DETROIT RIVER INTERNATIONAL CROSSING STUDY

Meeting with Spring Garden Residents

October 15, 2008

Proposed Design Revision

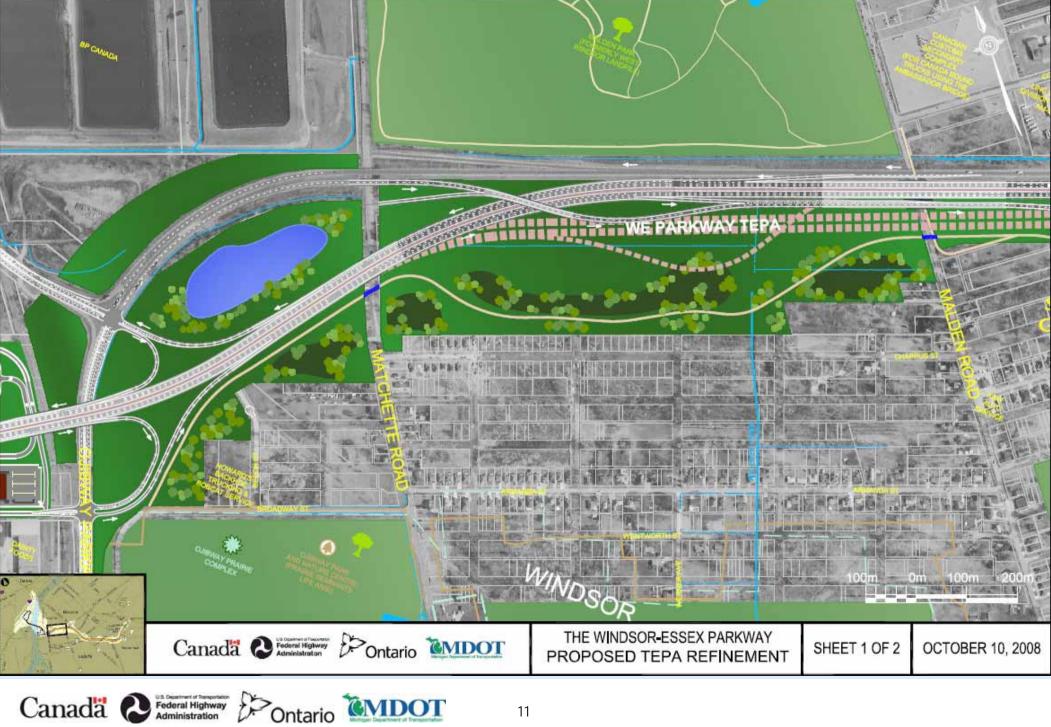
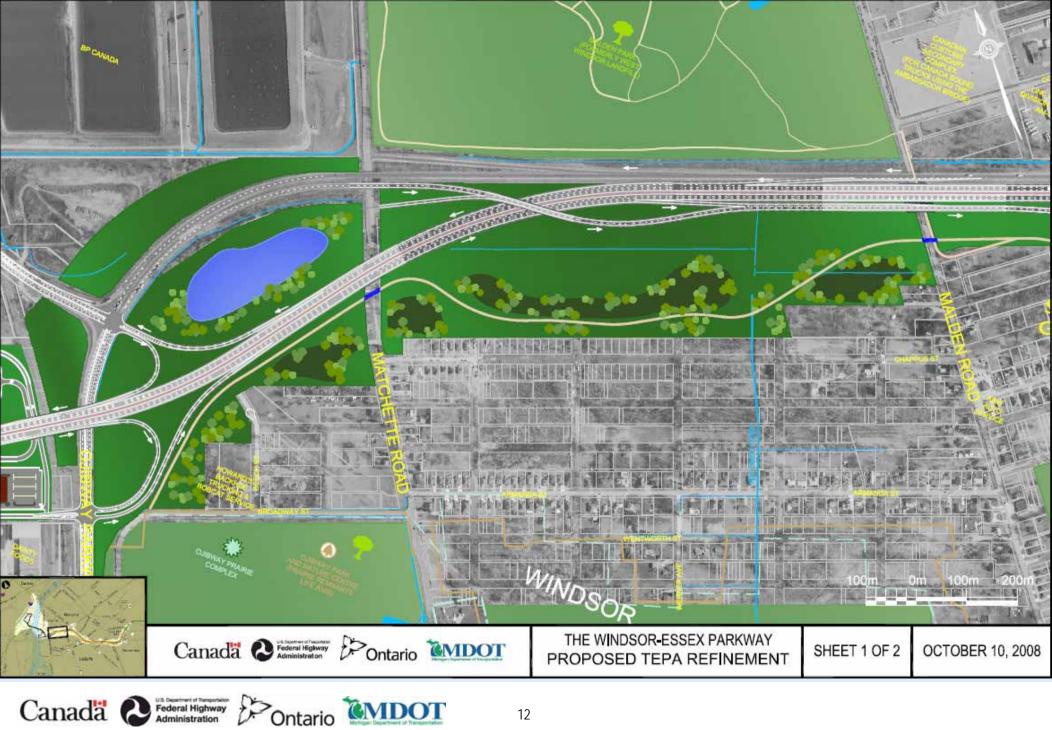
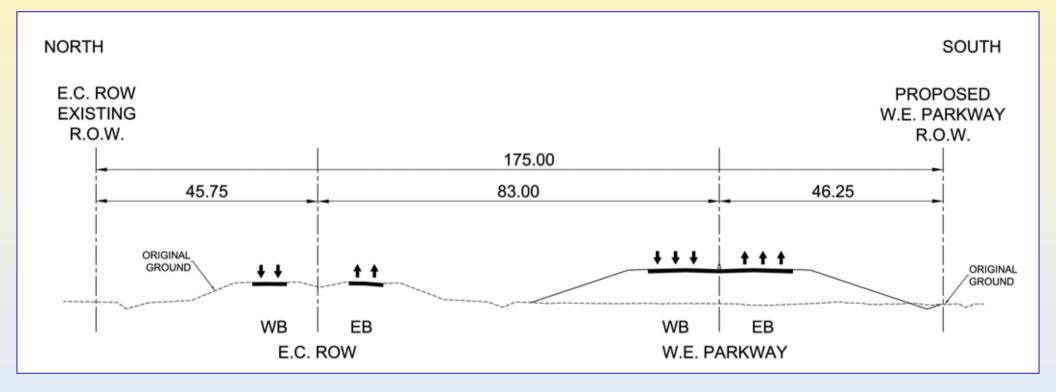
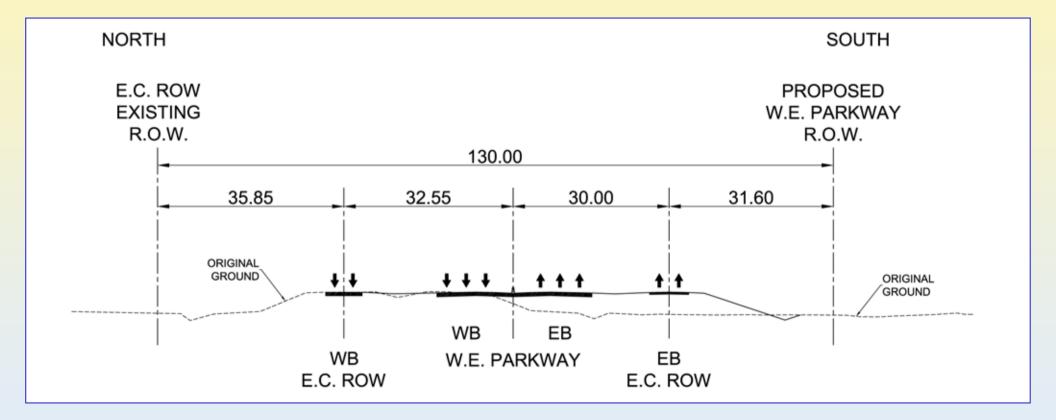
- Current design has the Windsor-Essex Parkway <u>beside</u> the E.C. Row corridor
- Proposed design <u>integrates</u> the Windsor-Essex Parkway into the E.C. Row corridor

- Increases distance from Windsor-Essex Parkway to Spring Garden Road by up to 60 m
- Reduces the impact of the eastbound ramp from W-E Parkway to E.C. Row
- Reduces impact to natural area (predominantly forested) by 25 acres (10 Ha)
- Provides larger buffer for Spring Garden residents
- Preserves areas of significant natural habitat
